| Request | - | Amendment to Special Use Permit originally granted by Ord. 218-19, for Christ the King Church & School site expansion. |
| Location | - | 4757 Monroe Street |

SPECIAL USE PERMIT
TOLEDO PLAN COMMISSION
REF: SUP25-0042
DATE: December 4, 2025
TIME: 2:00 P.M.

SITE PLAN

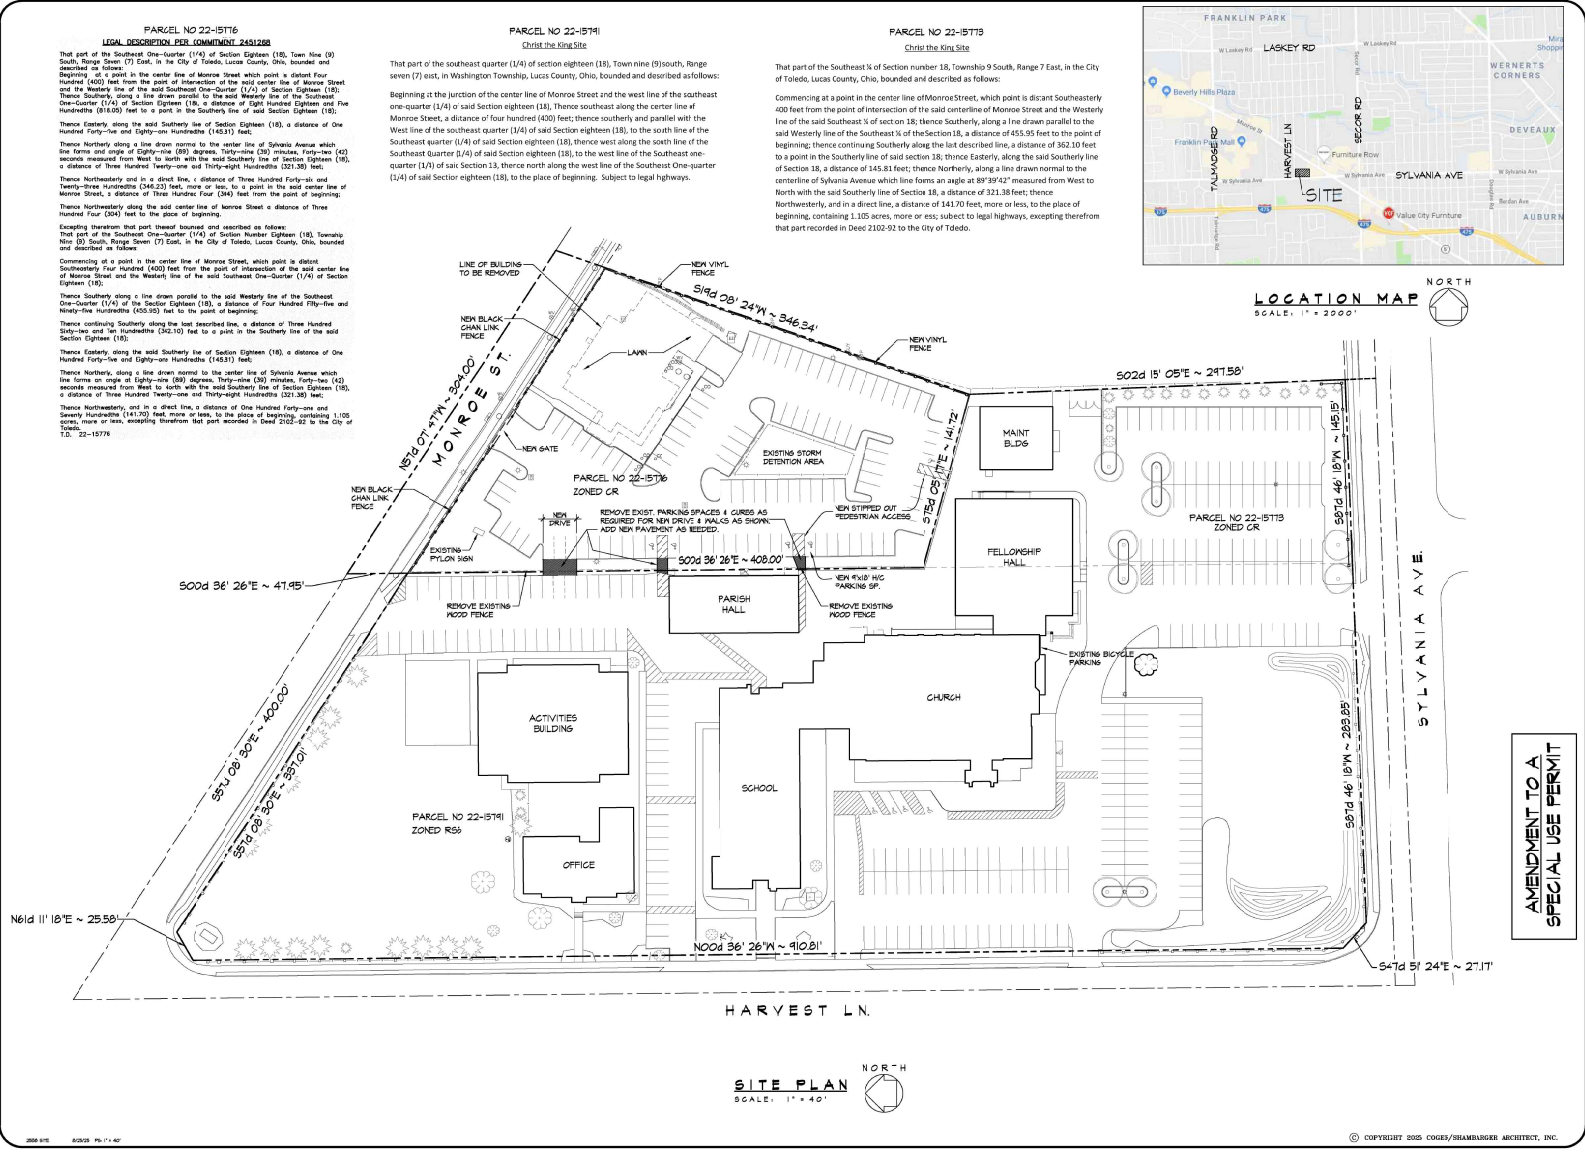
The area of expansion contains an existing one-hundred and ten (110) space parking lot, an adequate storm detention area, and a grassy lawn where a restaurant building previously stood. The site plan depicts the removal of six (6) parking spaces and relocation of accessible parking spaces. A new drive aisle between the parking lot and existing campus is proposed along the western boundary. Pedestrian walkway connections from the parking area to the main campus are also proposed. With the proposed modifications of this site; one-hundred and six (106) parking spaces will remain. Pursuant to TMC§1107.1701; four (4) car-accessible and one (1) van-accessible spaces with abutting five (5') foot-wide and eight (8') foot-wide aisles respectively are required. The site plan indicates a total of five (5) accessible parking spaces however, the abutting aisles are not dimensioned. Therefore, as a condition of approval a revised site plan shall be submitted indicating the accessible parking abutting aisle widths in compliance with this section.

Per TMC§1107.0304; one (1) bicycle parking space is required per ten (10) parking spaces. A revised site plan depicting the addition and location of eleven (11) bicycle parking spaces shall be provided, and is listed as condition of approval.

The submitted site plan does not indicate landscaping; however, the site underwent a Major Site Plan review in 2005 as case number SPR-45-05. The review for a new restaurant building required ample landscaping within the interior and perimeter of the parking lot. Existing landscaping that remains may count towards the requirements for the expansion area review under the provisions of TMC§1108.0407 – *Tree Preservation and Credit for Existing Landscape Materials*. As a condition of approval, a revised landscape plan that meets the applicable regulations of Chapter 1108 – *Landscaping*, shall be submitted to the Plan Director.

Pursuant to TMC§1113.0702(B), if a site undergoes Plan Commission review, any nonconforming signage on the premises shall be brought fully into compliance with the Sign Code as a part of the review and approval process. The site plan indicates the existing sign to remain, however, it is not compliant with current sign code regulations.

The existing sign is nonconforming as it is well above the maximum height allowed of twelve feet (12'), it does not include brick, stone, or metal; and the copy area is wider than the supporting structure. The exact height and sign face dimensions are unknown to staff. The existing sign cabinet could potentially be approved for re-use at this site however, the design and height of the overall sign is required to be brought into compliance, or removed from the site and is listed as condition of approval.

17. Parcels 22-15776, 22-15773, and 22-15792 shall be combined by filing a combination request with the Lucas County Auditor's Office.
18. Based on the one-hundred and six (106) parking spaces, four (4) car-accessible spaces with abutting five (5') foot-wide aisle; and one (1) van-accessible space with an eight (8') foot-wide aisle are required per TMC§1107.1701. **The number of spaces provided is acceptable; however, the width of required abutting aisles are not depicted and shall be shown on a revised site plan.**

19. A total of eleven (11) bicycle spaces are required. Individual spaces shall be at least 2' by 6' per slot per TMC§1107.0902(A). **Not depicted, shall be shown on a revised site plan.**

- a. A fifteen (15') foot frontage greenbelt with one (1) tree provided for every thirty (30') feet of frontage, and a solid evergreen hedge planting is required along Monroe St. **Not depicted, a revised landscape plan shall be submitted.**

- b. Perimeter landscaping must be installed along any parking lot area adjacent to a street, place or driveway, or which is visible from an adjacent property. Perimeter landscaping must be ten feet (10') in width along the eastern property boundary and include one (1) canopy tree for every thirty (30') linear feet, plus a continuous shrub with a minimum height of eighteen (18") inches when installed. **Not depicted, a revised landscape plan shall be submitted.**

- j. The location, number, height, diameter and species of any materials to be planted and maintained, as well as the location and number of any existing plantings to be retained. Applicant has the option to request credit for the existing tree under TMC§1108.0407. **Not depicted, applicant shall provide a landscape plan showing detail of existing and proposed landscape materials.**
